United States Department of the Interior

NATIONAL PARK SERVICE
Southeast Regional Office
Atlanta Federal Center
1924 Building
100 Alabama St., SW.
Atlanta, Georgia 30303

The National Park Service (NPS) appreciates the opportunity to be a cooperating agency with the U.S. Nuclear Regulatory Commission (NRC) in the review and development of the Supplemental Environmental Impact Statement (SEIS) for the 20-year Subsequent License Renewal for Turkey Point Nuclear Plant Units 3 and 4 proposed by Florida Power and Light (FPL). FPL has requested an extension of the operating license for the two units, with Unit 3 being extended from 2032 to 2052 and Unit 4 from 2033 to 2053. We offer the following general comments on the preliminary draft SEIS and specific comments (Enclosure 1), which are limited to Chapter 3: Affected Environment, Chapter 4: Environmental Impacts, and Section 4.116: Cumulative Impacts. The NPS may have additional comments once the remaining sections of the SEIS are developed and the entire document is assembled.

Specific Comments – Preliminary Draft SEIS

Category 3

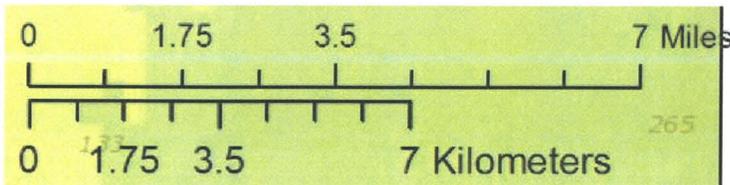
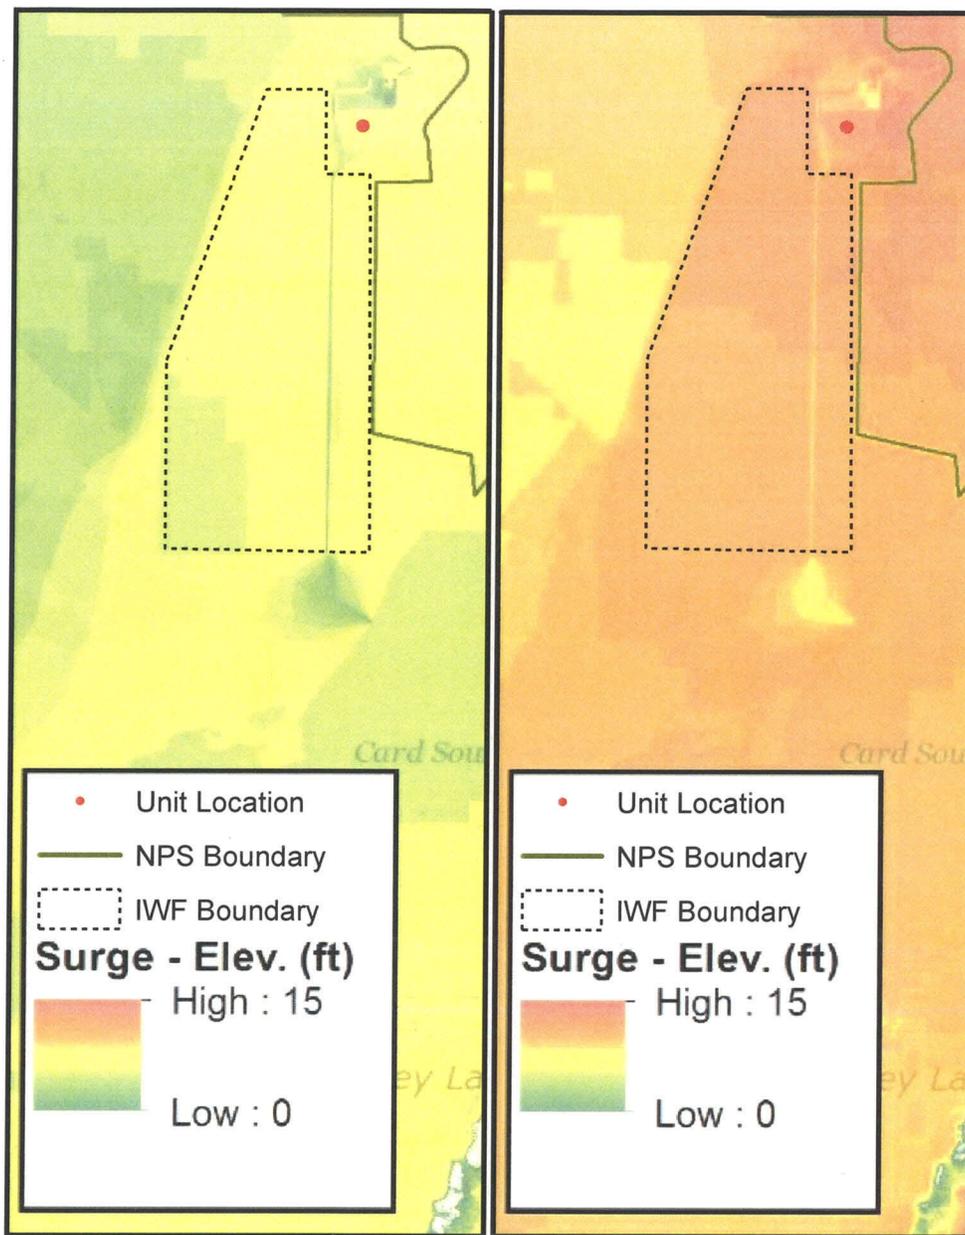
The Industrial Wastewater Facility (IWF) is highly susceptible to hurricane driven storm surge events. These two maps show outcomes from NPS runs of the National Weather Service's Sea, Lake and Overland Surges from Hurricanes (SLOSH) model conducted earlier this year. Both the Category 3 (left) and Category 5 (right) hurricane maps show anticipated storm surge based on high tide. Results indicate that storm surge waters would flow over levees separating the IWF from Biscayne National Park (NP) and Biscayne Bay (Bay). Such events increase the likelihood that contaminants in the IWF waters, as well as newly stored dredge spoils from Units 6 & 7 excavation, would enter Biscayne NP and Bay via overwashing and/or breach of the eastern levee (as discussed in accompanying map) in the foreseeable future. This concern is not analyzed in either the FEIS or Safety Report.
